DFT PR-2024-010446

SI-2024-00774

RESPONSE TO: Code Enforcement Comments

CONSTRUCTION OF NEW FACILITY FOR
D&B U-SELL-IT
 401 UNSER BLVD NW
 ALBUQUERQUE, NM 87121

BERM DETAIL

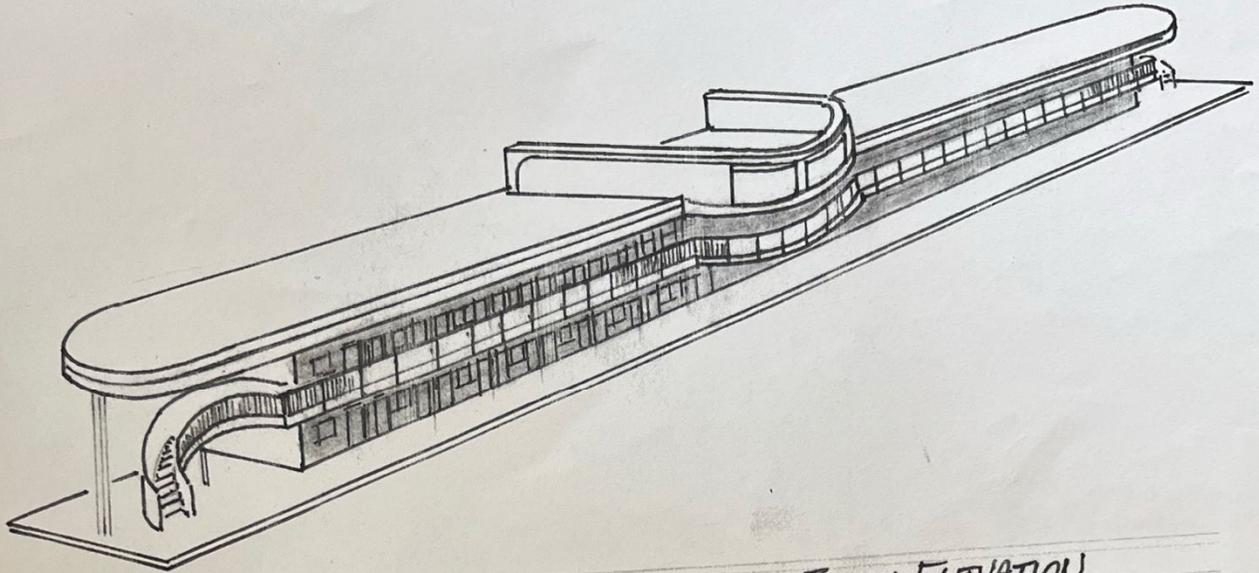
Clarify the details for the 100 ft landscape areas, and how/where berming screening areas are being used to meet the requirements of the Clifford Park plan.

8. The CWMP only calls for a berm to be installed along the full length of Tract B at Unser Blvd. For this development, a 3’ high landscaped earthen berm has also been added along Saul Bell Rd. and Bluewater Rd. to comply with the IDO requirement to prevent headlight beams being directed into the traffic lanes.

The tree requirements are shown on landscaping plan. Parking lot landscaping meets the required parking space trees. Trees have been planted within 100 ft of park and display areas as depicted by the dotted round circles on the landscaping plan. The CWMP only calls for a berm to be installed along the full length of Tract B at Unser Blvd. For this development, a 3' high landscaped earthen berm has also been added along Saul Bell Rd. and Bluewater Rd. to comply with the IDO requirement to prevent headlight beams being directed into the traffic lanes

OFFICE BUILDING - FRONT ELEVATION

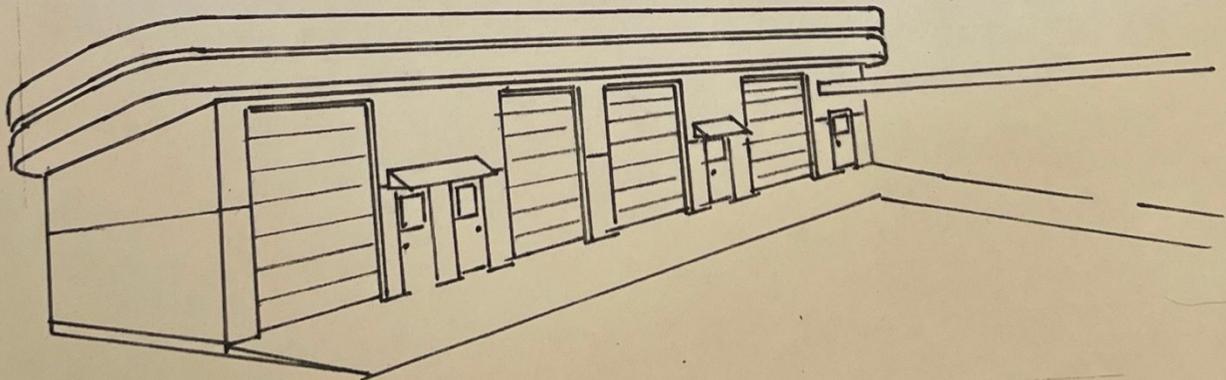
- **Elevation pages need to include measurements, dimensions, and information regarding screening. Provide detail to demonstrate and explain compliance with all sections within 5-11-E and 5-11-E-2.**

Include detail regarding how the façade and colors will meet the Clifford plan design requirements.

10. See [drawings A1 Office Building and A6 Shop Building](#) for the exterior elevations of the buildings. The finish materials and colors are specified for primary and secondary surfaces as per CWBP. Concept designs are shown here for visual clarification.

The CWMP Section *BUILDING REGULATIONS* details various means and measures to be employed in the façade design of buildings. These definitions and the IDO requirements are similar enough that one reflects the other. Both the CWMP and the IDO concerns are addressed as described below. The Building Elevations are shown on Sheet A1 Office Building and Sheet A6 Shops Secondary Building.

Existing Building Elevation drawings have been revised with additional information as requested. The finish materials and colors are specified for primary and secondary surfaces as per CWBP Master Plan: “Building design and construction shall be used to create a structure with attractive fronts of quality materials. The quality materials must be applied to exterior walls on the front of the building and to the sides of the building up to 100' from any public street curb.”

1 AC1 SITE DEVELOPMENT PLAN

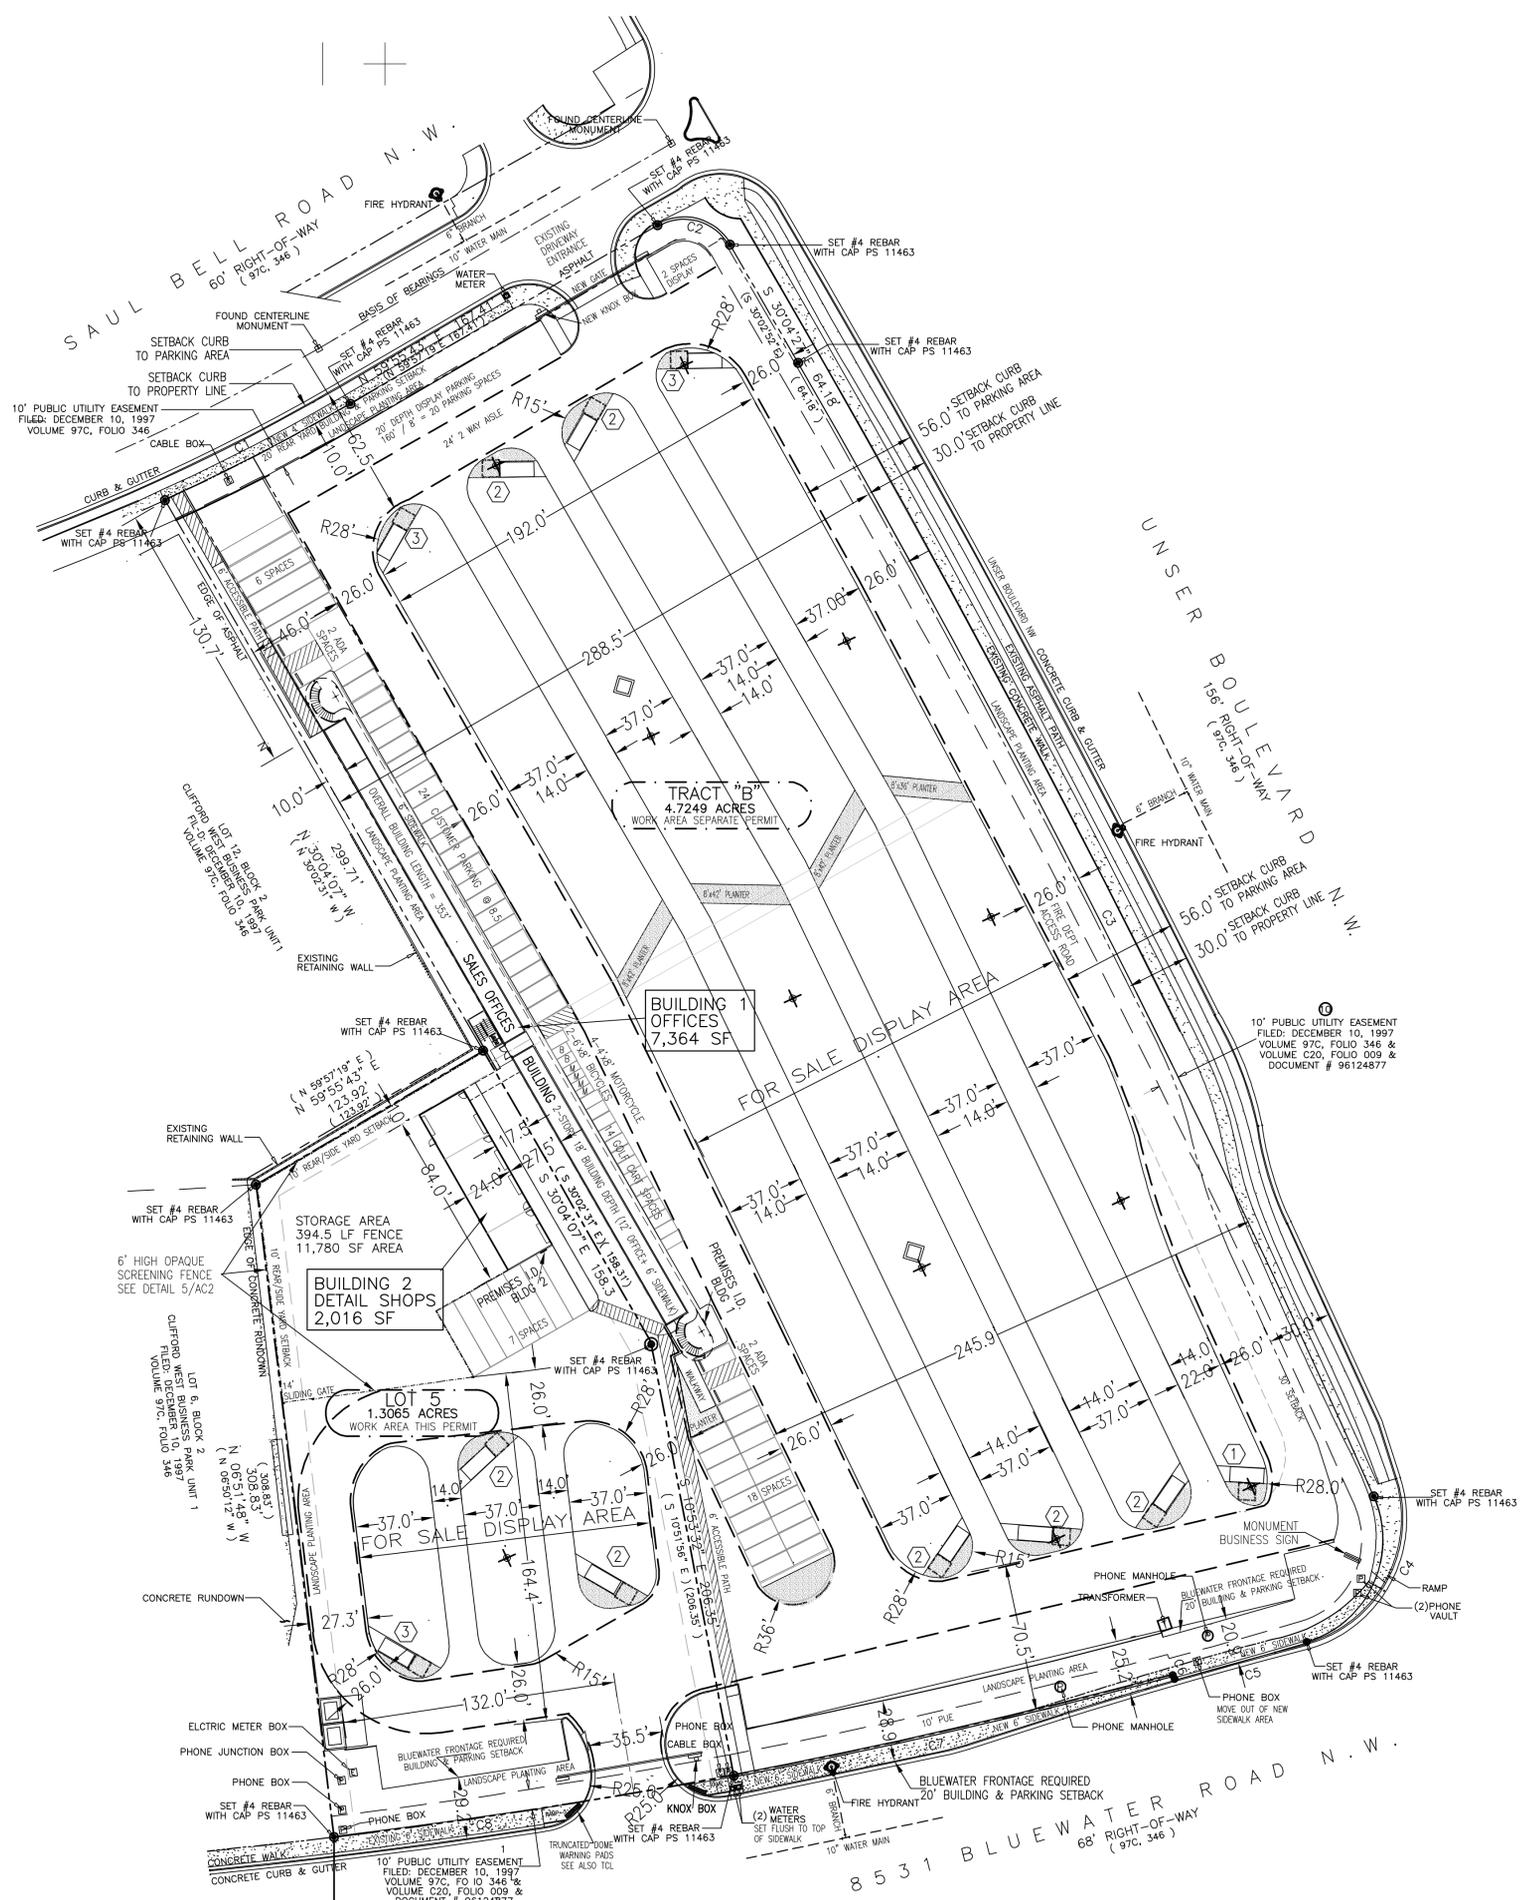
2. CWBP SETBACKS (**as shown on Site Plan AC-1**)

- **With a Bluewater address, the Site Plan, measurements, and Landscaping Plan will need to reflect that as the front lot line.**

The Site Plan needs to include measurements for setbacks.

▪ **Project and application numbers must be added to the Site Plan and any associated Infrastructure List. Along with the DFT signature block.**

The property address for both parcels has been established as 8531 Bluewater Rd. which sets the Front Lot Line on the southern edge of the property. Front Setback to buildings is 20 feet to buildings and 15 feet to parking areas. Building Setback - buildings are erected to the rear of the lots and well exceed the required setbacks.

The property address has been assigned as 8531 Bluewater Rd NW. This establishes the Front Line location on the south edge of Lot 5 and Tract B and is **reflected on Site Plan**

CWBP sets the measurement of setbacks to parking and buildings from the back of the street curb. The depth of the setback varies according to the classification of the street adjoining the property. Sites which front on more than one street must satisfy the Front Yard Setback for all such streets. The meaning of this requirement is that on corner lots the standard 10’ side or rear setback is not to be applied. For this project, all three street classifications are applicable. Setbacks are compliant as shown on the Site Plan Sheet AC1

-Project Number PR-2024-010446 and Application Number SI-2024-00774 have been added to the Site Plan and other associated documents. A DFT signature block has also been added to Site Plan. Other permit numbers related to this project are as follows: BP-2024-15892 (active); BP-2023-49573 (cancelled automatically while working on meeting requirements); GP-2024-16832; IL: PROJ ID 791882; ITEM #47140798).

3 PERIMETER WIRE FENCING

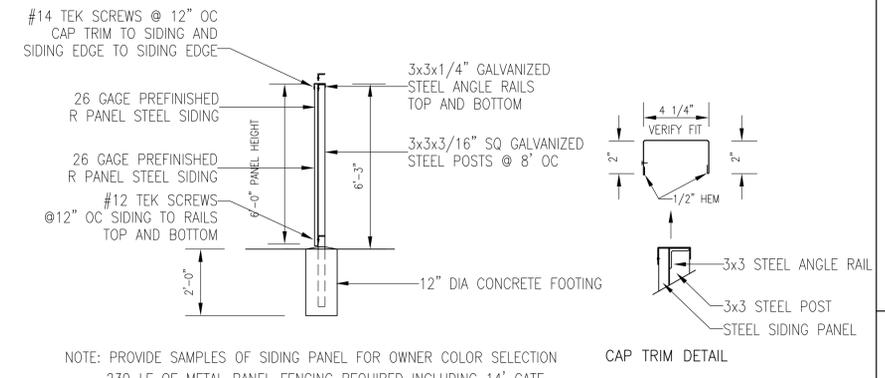
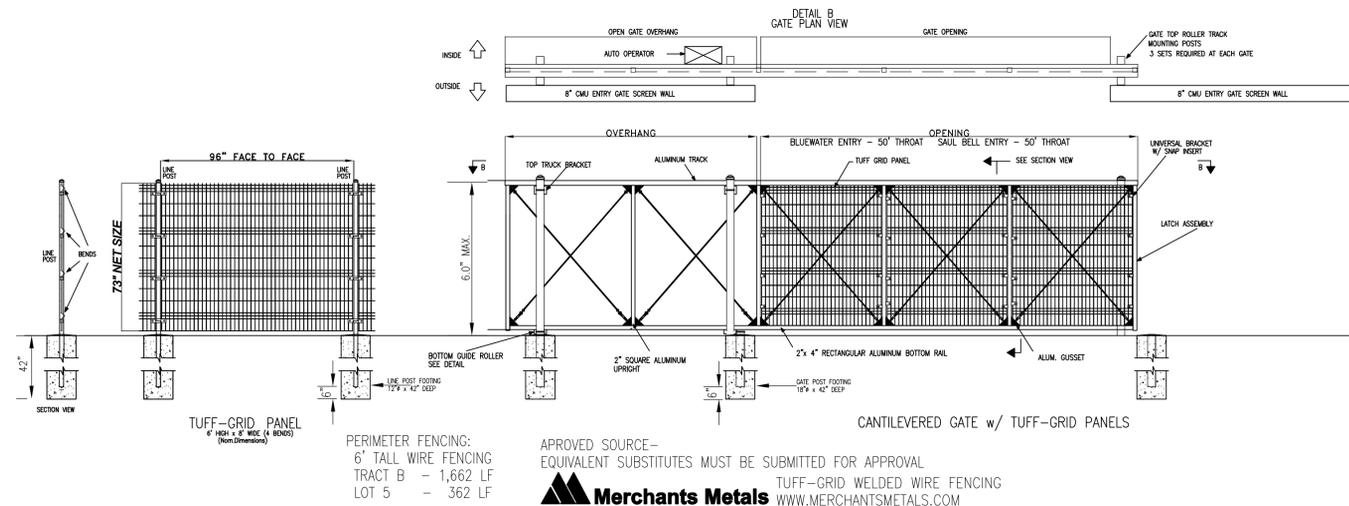
- **Confirm with Code Enforcement that the proposed metal fencing is meeting the material requirements of the Clifford West Plan and/or IDO standards.**

The CWBP does not provide any discussion of fence materials or design. The 6’ high, 3 crimp wire fencing specified for this project is the same as that which the City has commonly used for perimeter fencing of playgrounds and other public activity areas. Separate fencing permit has been applied for (GP-2024-16832).

1 E1 ELECTRICAL SITE PLAN

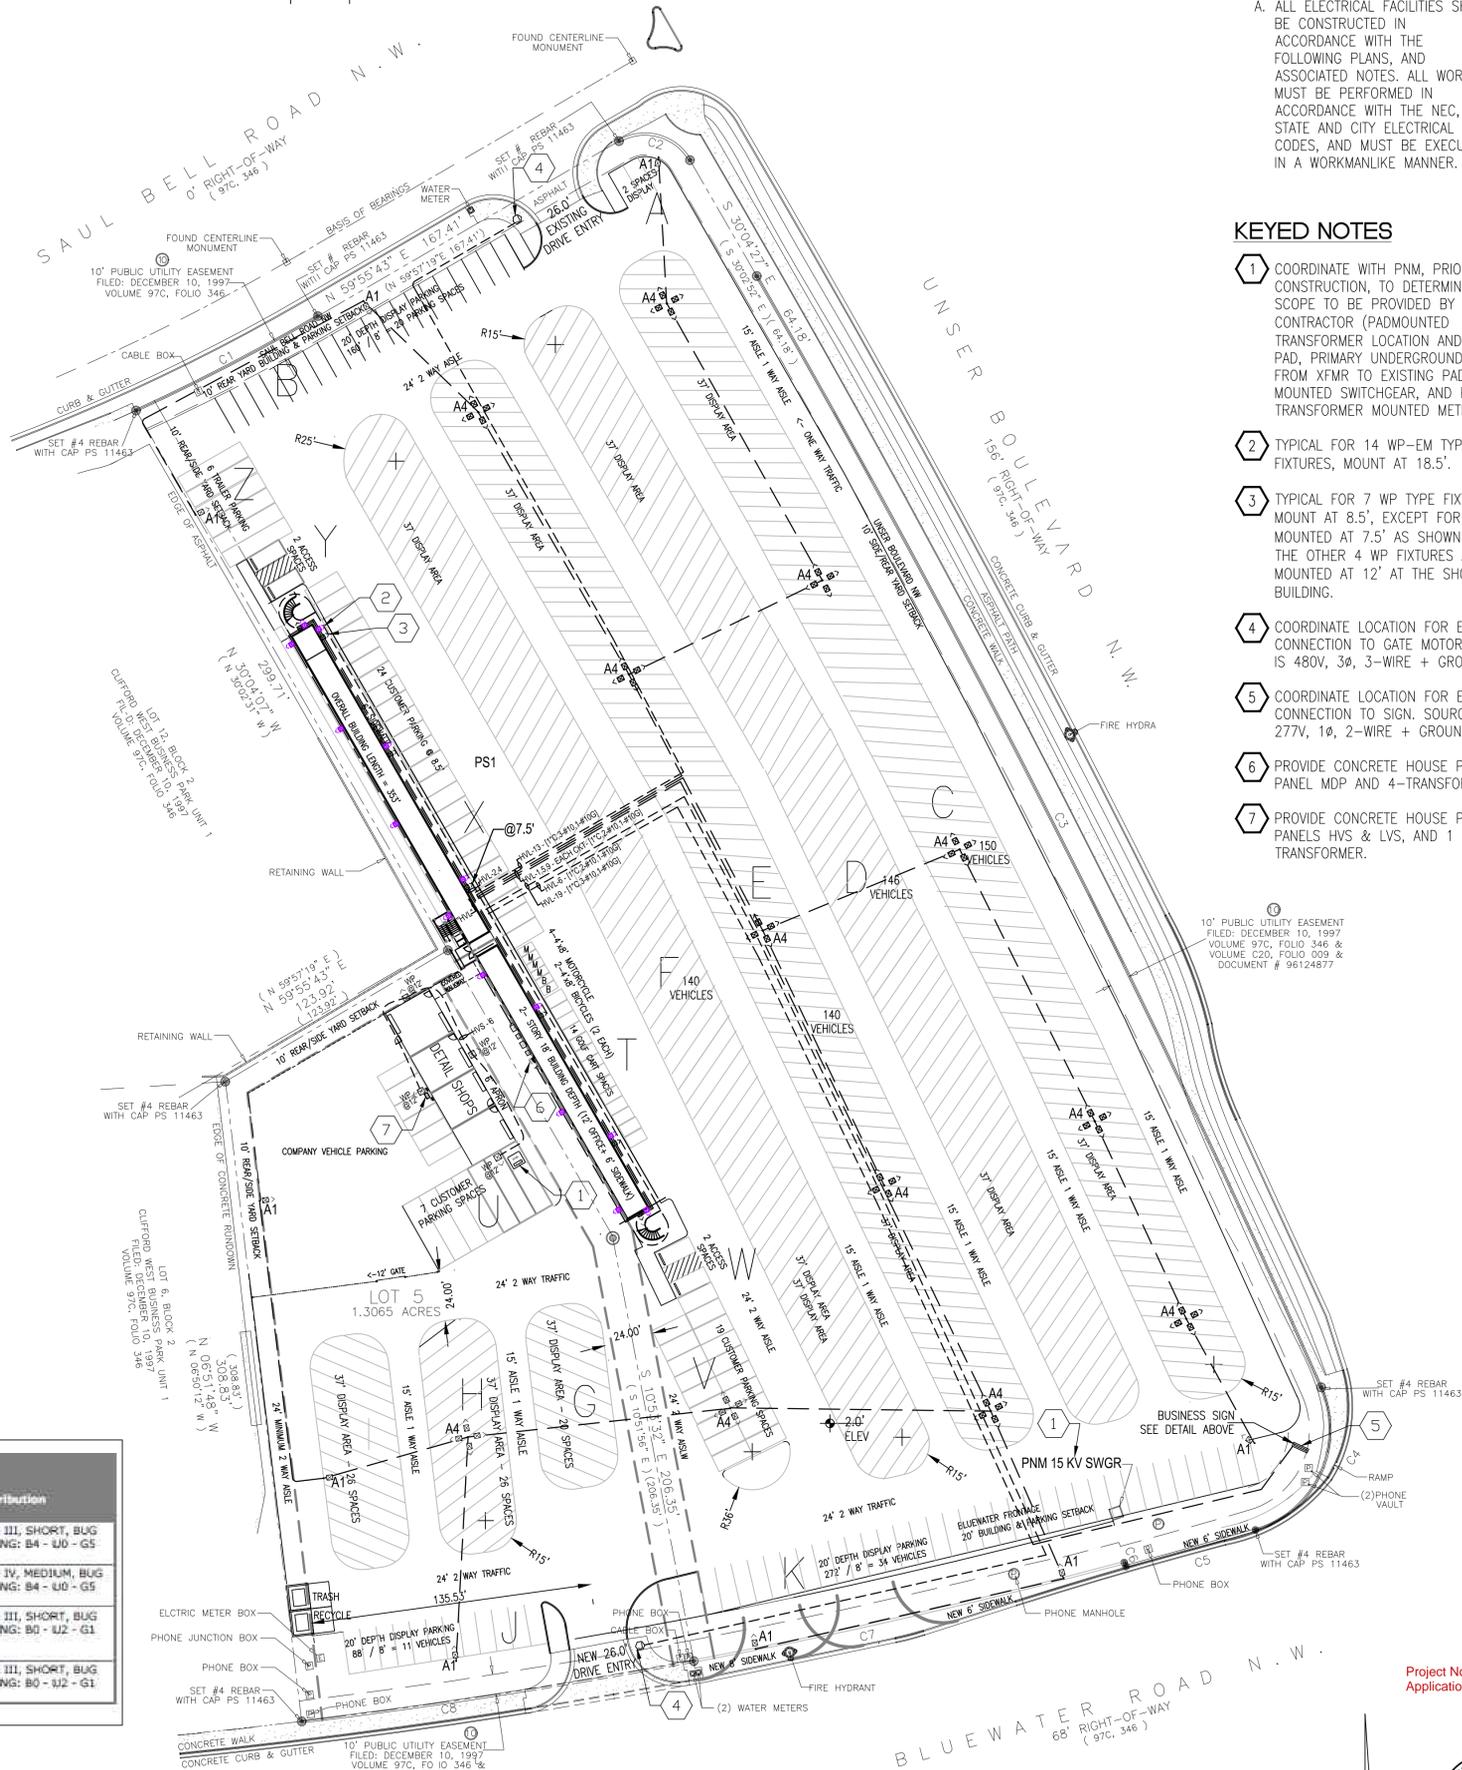
▪ **Provide a lighting plan with dimensions that meet the Clifford plan requirements.**

12. The exterior area lighting plan Sheets E1 and E1 Supplement have been clarified to improve the readability of illumination levels and dispersion patterns. (**Enclosed Rev. E1, & Supp.**) The light trespass limits surrounding the fence line are within 0.8 fc. The main site lighting is bordered by three streets: Saul bell Road NW, Unser Boulevard NW and Bluewater Road NW. The foot candle level on the fence line is the minimum for video surveillance to pick up activity to dispatch a quick response team with adequate information. **Exterior Lighting Compliance Certificate is also enclosed.**

The exterior area lighting plan Sheets E1 and E1 Supplement have been clarified to improve the readability of illumination levels and dispersion patterns. (Enclosed)
The light trespass limits surrounding the fence line are within 0.8 fc. The main site lighting is bordered by three streets: Saul bell Road NW, Unser Boulevard NW and Bluewater Road NW. The foot candle level on the fence line is the minimum for video surveillance to pick up activity to dispatch a quick response team with adequate information. **Exterior Lighting Compliance Certificate is also enclosed.**
